**PACIFIC GAS AND ELECTRIC COMPANY**  
**Wildfire Mitigation Plans Discovery 2022**  
**Data Response**

PG&E Data Request No.:	CalAdvocates_025-Q06		
PG&E File Name:	WMP-Discovery2022_DR_CalAdvocates_025-Q06		
Request Date:	July 8, 2022	Requester DR No.:	CalAdvocates-PGE-NonCase-2022WMP-25
Date Sent:	July 13, 2022	Requesting Party:	Public Advocates Office
PG&E Witness:		Requester:	Holly Wehrman

The following questions relate to PG&E's June 27, 2022 response to the *Revision Notice For Pacific Gas And Electric Company's 2022 Wildfire Mitigation Plan Update* issued by Energy Safety on May 26, 2022.

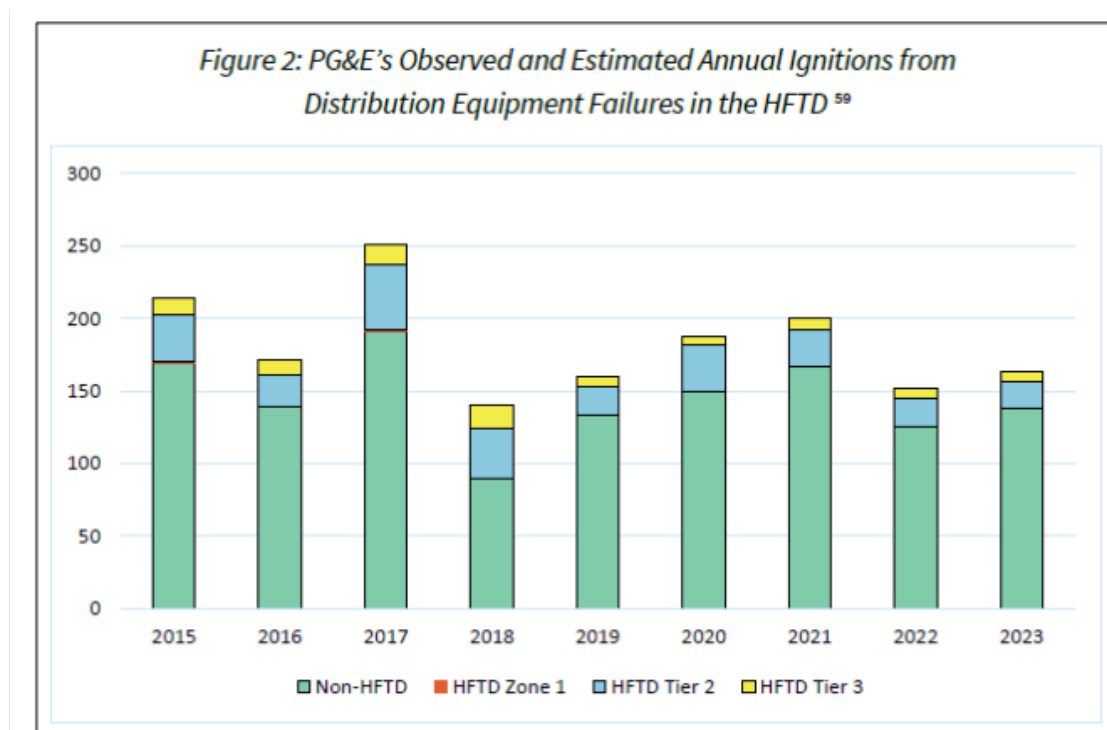
Page 16 of Energy Safety's Revision Notice includes the following chart, which shows a steady increase in non-HFTD ignitions from 2018 through 2021:

- a) Please list all causal factors to which PG&E attributes the increase in equipment-related ignitions from 2018 to 2021 in *non-HFTD*.
- b) Please list and briefly describe all actions PG&E is taking in 2022 to reduce the number of equipment-related ignitions in *non-HFTD*.

- a) Given the relatively modest year-to-year changes from 2018 to 2021, we believe this annual increase is likely due to random year-to-year variability in the number of ignitions, and not necessarily be representative of an underlying trend. Indeed, when comparing the ignition counts for the other years in the dataset, PG&E observed less equipment-related ignitions on average in the three years after 2018 (123) than the three years preceding it (139), despite the consistent annual increase in ignitions from 2018 to 2021.

The two tables below detail equipment-related CPUC-reportable ignitions in non-HFTD areas by year and equipment type per the ignition data included in Table 7.2 of PG&E's most recent Wildfire Mitigation Plan (WMP) quarterly update. Table 1 is a count of ignitions from 2018 through 2021 while Table 2 is a count of the difference from the previous year. On Table 2, positive reductions between one year and the preceding year are highlighted in green and increases in ignitions are in orange. The more detailed numbers in these tables, particularly those in Table 2, indicate that changes in ignitions are likely the result of year-to-year variability, and not necessarily indicative of a causal trend.

- b) PG&E is focused on reducing equipment-related ignitions in HFTD as that is where we can most contribute to public safety and reduce wildfire risk. Indeed, 99% of our wildfire risk occurs in HFTD and HRFA areas. However, despite the lower risk profile, we still perform a significant amount of equipment-related fire mitigation work in non-HFTD areas. Specifically, we undertake Patrols Detailed Inspections, Infrared Inspections, and Intrusive Wood Pole Inspections in non-HFTD areas to ensure the integrity of our infrastructure. In addition to these inspections, we also perform maintenance tag work in non-HFTD areas, with tags being worked

We also perform a large number of equipment-specific replacement programs in our non-HFTD areas such as pole replacement, pole restoration, overloaded pole replacement, overloaded transformer replacement, non-exempt surge arrester replacement, tree attachment replacement, and partial voltage detection installation. To supplement these equipment-specific programs, PG&E also performs routine vegetation management and animal abatement to minimize contact from object with PG&E assets in non-HFTD areas. Furthermore, in locations that have a heightened wildfire risk — namely the areas within High Fire Risk Area (HFRA) but outside HFTD and HFTD buffer zones — additional de-energization protection is implemented in times of elevated fire risk through our Enhanced Powerline Safety Settings (EPSS), and Public Safety Power Shut-off (PSPS) settings. We have found these programs to offer substantial wildfire mitigation, with EPSS in particular demonstrating an 80 percent reduction in CPUC-reportable ignitions in our 2021 pilot program.<sup>1</sup>
